MEMORANDUM

DATE:	February 12, 2021	RWDI REFERENCE #: 1904405
TO:	Anthony Witherdin	Director, Key Sites Assessments - DPIE
FROM:	Kevin Peddie	Email: kevin.peddie@rwdi.com
	Michael Pieterse	michael.pieterse@rwdi.com
RE:	Solar Access – City of Sydney Review Response Waterloo Metro Quarter – Building 4

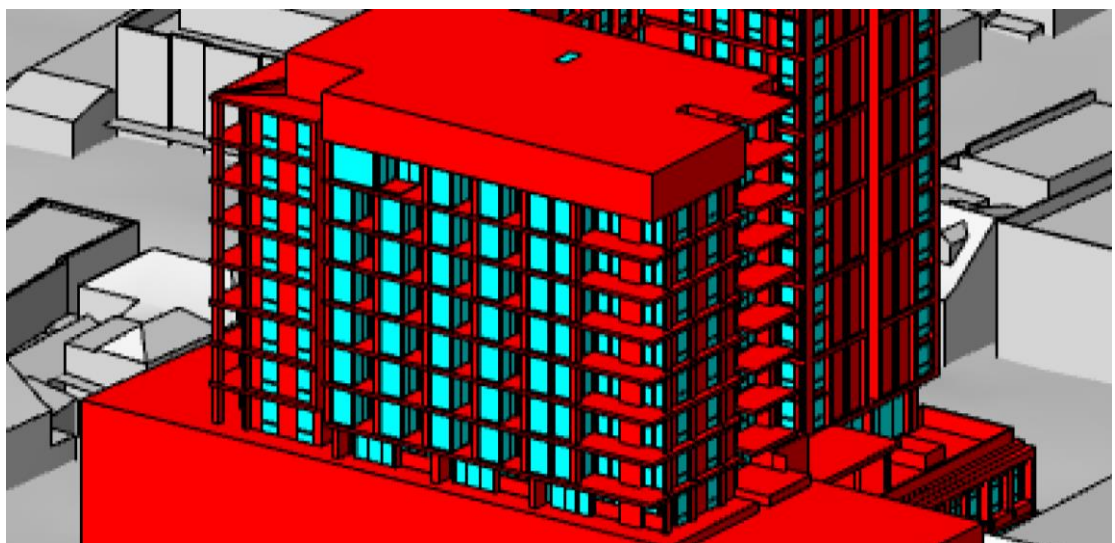
Item 27 of the City of Sydney comments under the heading Amenity – social housing pertains to the Solar Access requirement of the Apartment Design Guide and noted the following:

Solar access – The City notes that 15 of 70 apartments (21%) do not receive any direct solar access during mid-winter, four more than is permitted (15%) in accordance with Objective 4A-1 of the ADG. The City does not support the applicant's justification by including direct sunlight received after 3.00pm as this is not reflected in the design guidance or criteria and is of little thermal benefit due to the low altitude of the sun. Furthermore, some assertions regarding solar access are overstated, for example the quality of solar access to the living room of apartment 106 (the four-bedroom apartment). The analysis ignores the fixed vertical louvres to the east facing studios on Level 2 to 7 which block winter morning sunlight to living spaces. This removes 4 apartments per floor on levels 2-7 (24 apartments) and reduces the tally to well below 70%. This issue can easily be mitigated through a condition of consent requiring the fixed vertical blades to be changed to operable vertical blades. It should be noted that the Design Integrity Report records at item 4.03 that the supported privacy solution for these apartments is a "sliding privacy and sunscreen". This has now been removed from the scheme and further endorsement should be sought from the Panel.

The Solar Access study was undertaken by RWDI for the residential apartments associated with Building 4 of the development. Section 8 – Assessment and Findings, of the reports outlined the results of the modelling, noting the number of apartments which will have access to direct sunlight on June 21 between 9:00am and 3:00pm. The results provided an initial summary of the number of apartments which satisfied both direct sunlight to the living space as well as the private outdoor area, as well as a breakdown of each component. The assessment for the number of apartments which do not receive access to direct sunlight between 9:00am and 3:00pm for at least 15minutes is also detailed below.

Concern is raised with regards to the ability for the 4 eastern apartments on Levels 2 to 7 to maintain solar access due to potential shading from the vertical louvres hence note that these apartments should not be considered. As can be noted from the below image, which depicts a view from the sun at 9:15am on June 21, the sunlight is not only on the eastern façade, but also on the northern aspect of the glazing for the living space areas on these levels. Hence irrespective of the design of the vertical louvres, the living space will maintain at least 2hrs of direct solar access to the living space and private outdoor areas.
